**Airport
Land Use
Commission**

Re: Mariposa Energy Project
CEC Docket #09-AFC-03

The Contra Costa County Airport Land Use Commission, met on October 14, 2009 and November 5, 2009, to review the Mariposa project (CEC Reference number 09-AFC-03).

WIND COVERAGE
March 22, 1990 - April 25, 1991
Source: On-Site Wind Sensor

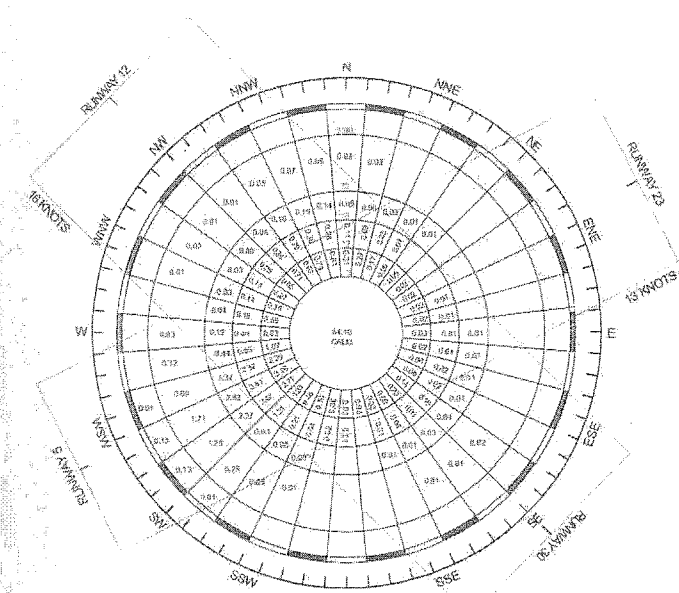
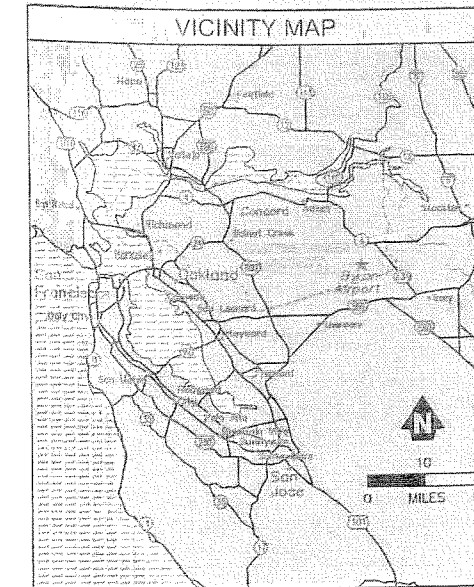
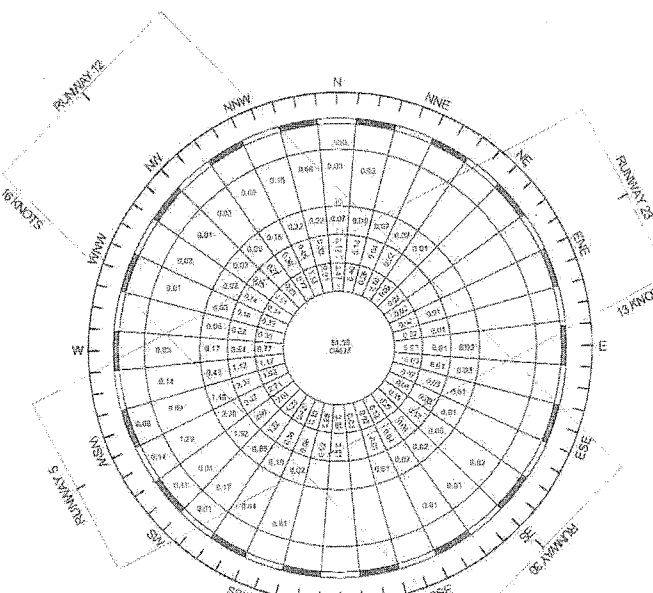
Information Request #4: We request that CEC repeat information request #1 with a wind of 12 knots. Approximately 54% of the time, "calm" winds of less than 8 knots from all directions prevail at the Byron airport. Approximately 23% of the time, there is wind from the southwest that blows in a range of 8 to 16 knots (average of 12 knots). This wind may have the potential to blow the powerplant plume toward the instrument approach of Byron's main Runway 30. We would like to know how far the plume is shifted at each of the test altitudes. While ultralights and gliders will likely use the shorter cross-wind runway 23 under this wind condition, larger aircraft will likely use the longer runway 30 because of its length. A copy of the wind rose for the Byron Airport, as taken from the latest master plan for the airport, is attached for reference.
